Whitehorse Amendment C175

Box Hill Central

Expert Urban Design Evidence

Mark Sheppard

Figure 8 - Proposed DDO6 Map 2 Sub-precinct boundaries

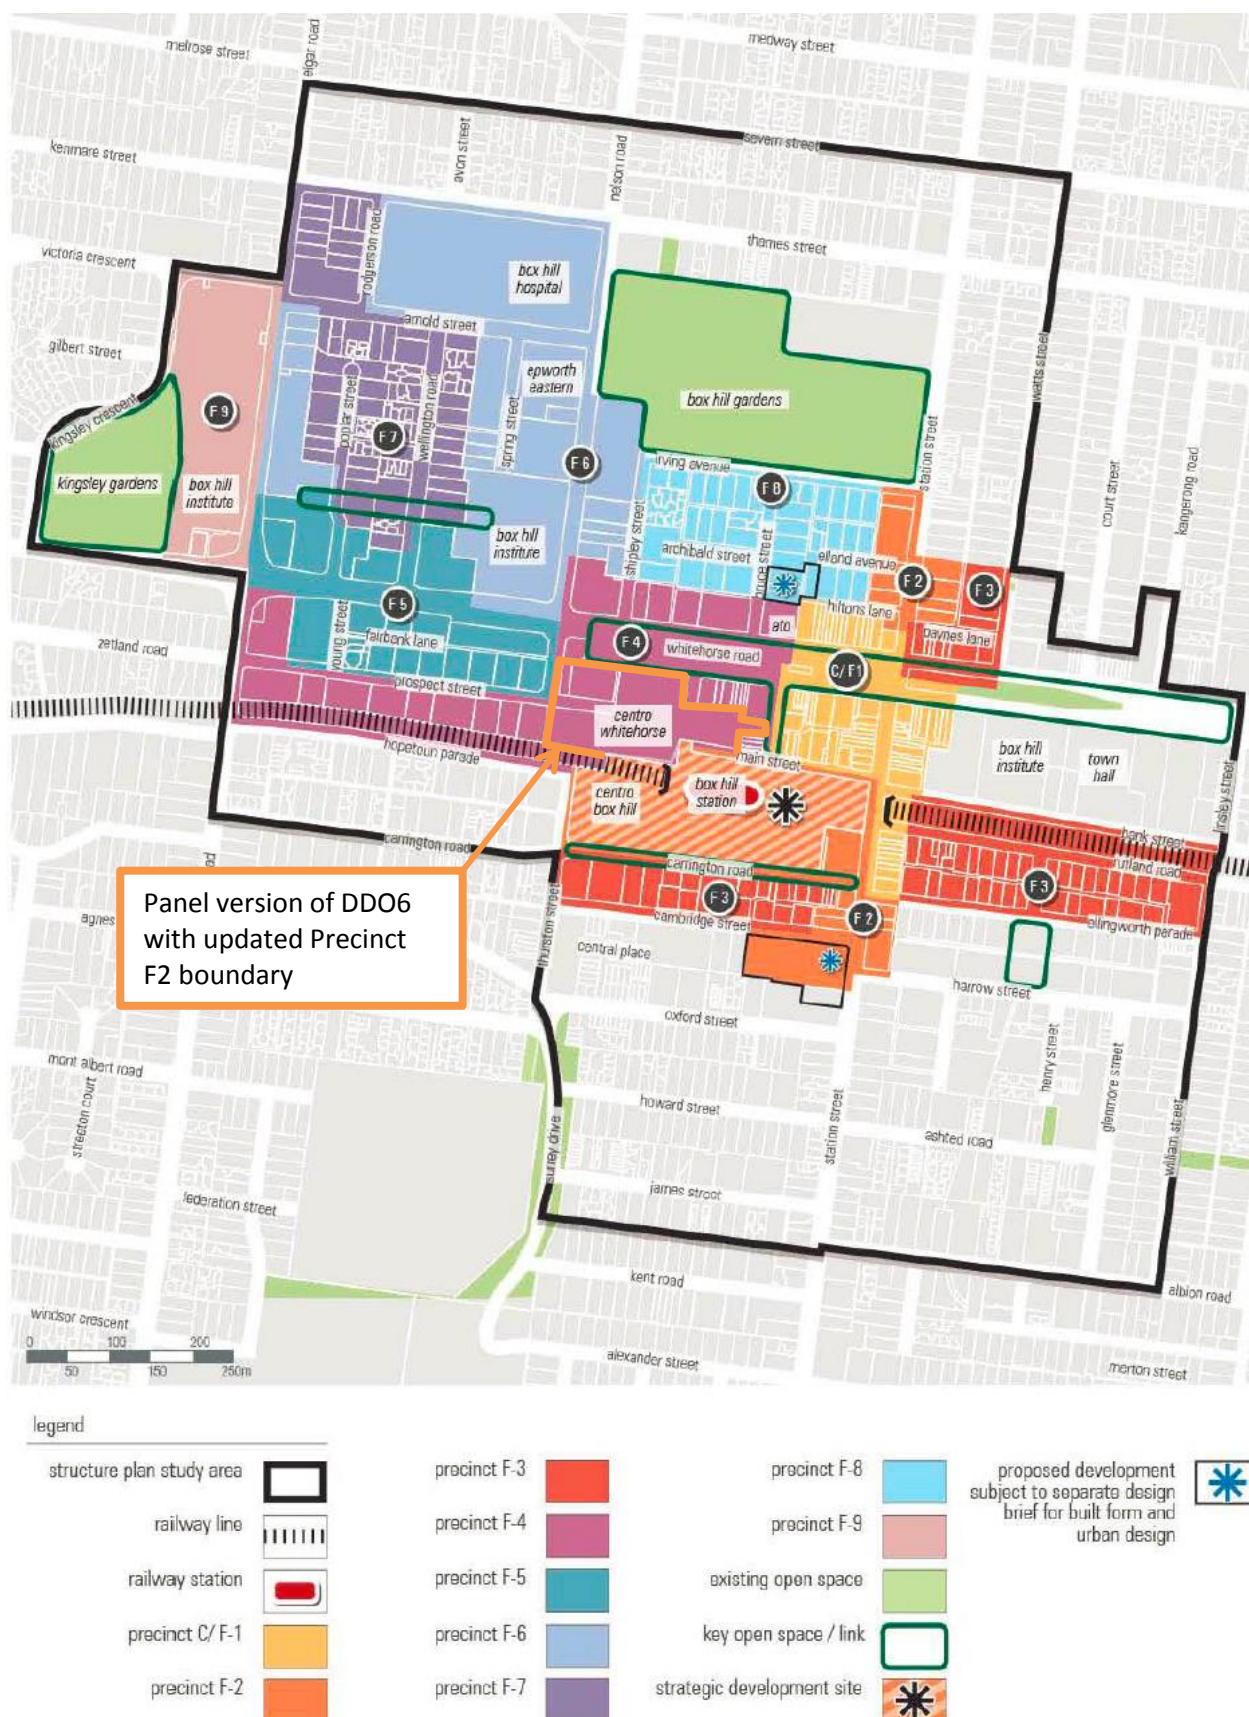
- [30] The exhibited DDO6 shows Central North within Sub-Precinct F4 and Central South within Sub-Precinct F2. More recently, Council’s representative has provided tracked changes to the exhibited DDO6 that Council supports, which shows both Central North and Central South within Sub-Precinct F2 and both are marked as ‘strategic development sites.’

- [31] Sub-Precinct F2 is broader than the Vicinity land, also including land along Station Street to the south and the Council-owned car park on the south side of Cambridge Street. This is curious, as the other properties in this sub-precinct share very little in common with Vicinity’s land. They are much smaller properties (see Box Hill Metropolitan Activity Centre Built Form Guidelines Figure 5), and more distant from the train station and bus interchange.

- [33] In relation to Sub-Precinct F2, the exhibited version of DDO6 stated that *“A plot – ratio approach to support greater development scale is applicable on Strategic Development Sites (to be determined) subject to positive contribution to its local context.”* This was presumably a reflection of the statement within the Box Hill Metropolitan Activity Centre Built Form Guidelines (‘the Guidelines’) that *“The City of Whitehorse seeks to explore options to encourage development outcomes which deliver local net community benefits negotiated between Council, prospective developers and community representatives”* (page 12).

- [34] Given that Central South was the only nominated strategic development site, the reference to a 'plot - ratio approach' seems to be an acknowledgement that it carries the potential for a greater contribution than is possible within the proposed built form parameters, but that the work has not been done to define that potential. If that is the case, why was it not unambiguously nominated for a separate design brief exercise, in the same vein as the Council car park site (rather than only if it seeks to exceed 12 storeys, like any other property in this sub-precinct)? Notably, the plot ratio approach is not further elaborated within the proposed DDO or the supporting Built Form Guidelines, which makes it of little utility in guiding applicants or planning authorities. It has now been deleted from the Panel version of the DDO.

- the Guidelines' analysis and objectives which support greater heights on larger sites and the topographic high point.
- [53] Therefore, I recommend removing Vicinity's land from the Amendment. Alternatively, it could be identified as a separate precinct, and provisions specifically applying to it limited to sub-precinct objectives and a Built Form Response seeking the preparation of a design brief to guide any major buildings or works.

Figure 9 - Proposed DDO6 – preferred maximum heights (storeys)

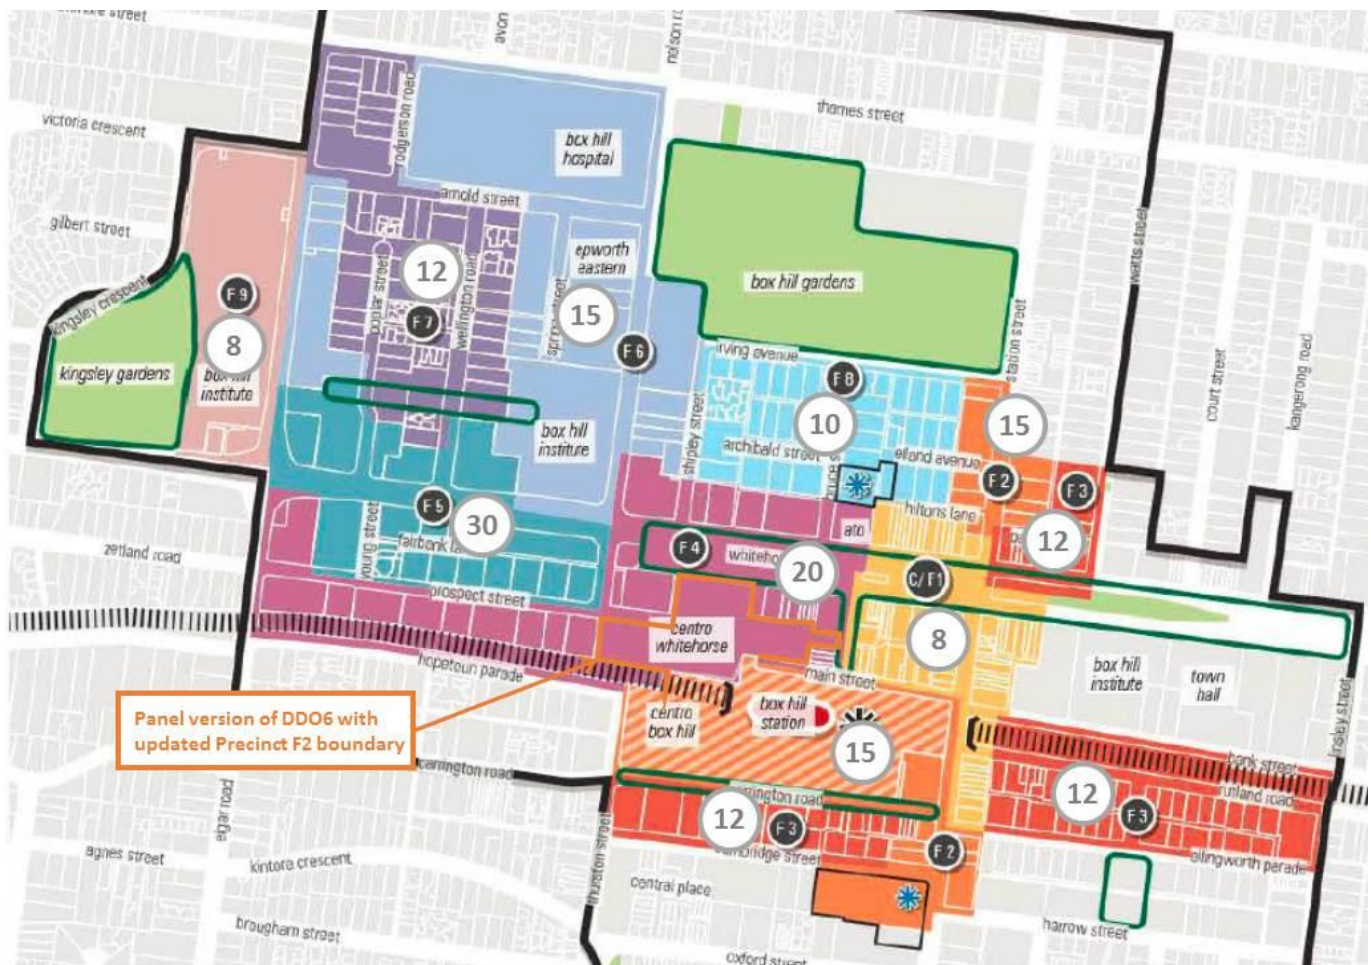
[39] In broad terms, the tallest buildings are proposed along Whitehorse Road between Elgar Road and Nelson Road (Sub-Precinct F5), with the maximum heights stepping down from there in all directions. The lowest preferred maximum heights are generally at the edges of the centre. The exception to this is Sub-Precinct C/F1, which is limited to 8 storeys despite being at the heart of the centre. In principle, this is generally consistent with the Structure Plan and existing Clause 22.07, which seek to limit building height between Whitehorse Road, Market Street, Main Street and Station Street (the 'Traditional Town Centre') to respect the existing built form character and heritage values (although they seek to limit height to 3 storeys).

- [40] The concept of heights stepping down at the edges of the centre is consistent with the Structure Plan. However, the location of the 'peak' on Whitehorse Road west of Nelson Road with a significant stepping down towards the Station is at odds with the Structure Plan's aim for *"significantly increased land use densities close to the railway station, and in the area between the station, hospitals and the TAFE."* It is also inconsistent with the principle of transit-oriented development, enshrined in the SPPF (e.g. at Clauses 11.06-3 and 16.01) and identified in the Guidelines as a Precinct Objective for Sub-Precinct F2 (specifically in relation to the Vicinity land).

- [44] Given the very large size of Vicinity's sites, their position at the top of the hill and their location literally on top of or adjacent to the train station, it is difficult to understand how the Guidelines' analysis leads to a preferred maximum height that is only half that for Sub-Precinct F5. Interestingly, Sub-Precinct F5 is where most of the tallest buildings are that have been built or approved to date (the exception being Sky ONE Box Hill at 545 Station Street, which is 36 storeys high and sits in Sub-Precinct F2). This may be a clue to the lesser height proposed for the Vicinity land, which happens not to have been the subject of development proposals for high-

- [46] Whilst the breadth and centrality of Whitehorse Road are undoubtedly attributes that suit taller buildings, it is difficult to understand why substantially lower preferred maximum heights are thought necessary on Vicinity's very large landholding, at the topographic high point of the activity centre, and with the best possible public transport accessibility and centrality to the activity centre. In my view, the Guidelines' purpose to create distinctive sub-precinct characters is not a sufficient justification to limit the potential height of development on Vicinity's land, given its excellent attributes for more intensive development.
